Access Compliance Report

Public Rights-of-Way

(Curb Ramps)

Intersection ID: 31523	Main Street: BACK_ACRE_DR	Cross Street: CALDWELL_RIDGE_PY	Location: W
ADA ID: 5BC6A8C83B84	Ramp Type: BlendTrans1	Initial Pass/Fail: Fail	Overall Compliance: No
Severity Score: 25			
Codes/Mitigation Info/Possible Solution		Field Measurements/Component Compliance

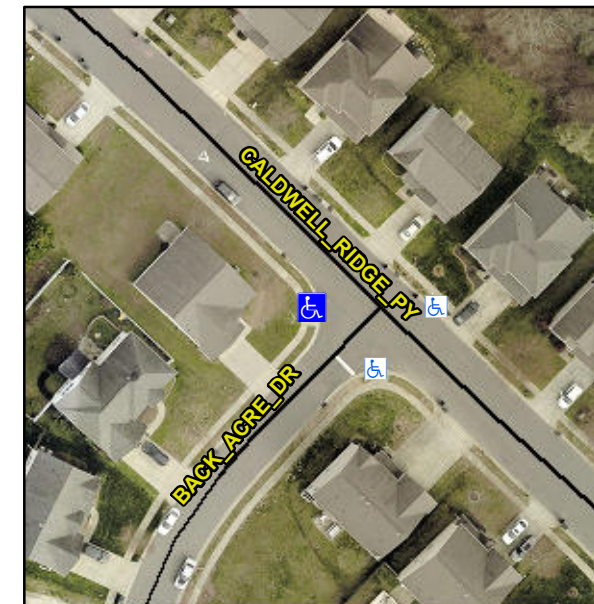
Compliance	Description	Data	Compliance	Description	Data
N/A	Ramp Length (in)	49.0	Yes	BlendTrans Slope (%)	3.8
Yes	Ramp Width (in)	52.0	No	BlendTrans XSlope (%)	7.5
N/A	Flare Type LT	N/A	N/A	Flare Type RT	N/A
N/A	Flare Slope LT (%)	N/A	N/A	Flare Slope RT (%)	N/A
N/A	Flare Traversable LT?	N/A	N/A	Flare Traversable RT?	N/A
N/A	Landing Length (in)	N/A	N/A	DWS Provided?	N/A
N/A	Landing Width (in)	N/A	N/A	DWS Contrast?	N/A
N/A	Landing Slope (%)	N/A	N/A	DWS Length (in)	N/A
N/A	Landing X Slope (%)	N/A	N/A	DWS Full Width?	N/A
N/A	Landing Curb? (Y/N)	N/A	N/A	DWS Offset (in)	N/A
N/A	Shared Landing?	N/A			
N/A	Gutter Ponding?	N/A	N/A	Gutter Slope (%)	N/A
N/A	Gutter Lip Ht (in)	N/A	N/A	Gutter X Slope (%)	N/A
N/A	Painted X Walk1?	No	N/A	Painted X Walk2?	No
	X Walk 1 Direction	To SE		X Walk 2 Direction	To NE
	X Walk 1 Width (in)	N/A		X Walk 2 Width (in)	N/A
	X Walk 1 Slope (%)	3.6		X Walk 2 Slope (%)	1.0
	X Walk 1 X Slope (%)	4.1		X Walk 2 X Slope (%)	7.1

N/A	Ramp inside XWalk1?	N/A	N/A	Ramp inside XWalk2?	N/A
	Road Slope (%)	6.1		Clear Space?	N/A
	Road X Slope (%)	3.7	N/A	Clear Space to XWalk (in)	N/A
N/A	Any Obstructions?	N/A	N/A	Storm Grate/Utility Hazard?	N/A
	Obstruction Type			Storm Grate/Utility Type	
		N/A			N/A
			Yes	Surface Condition? (G/P)	Good
			N/A	Curb Slope (%)	N/A

Remove & Replace Curb Ramp With Two New Directional Ramps or Equivalent.

R304.5.3
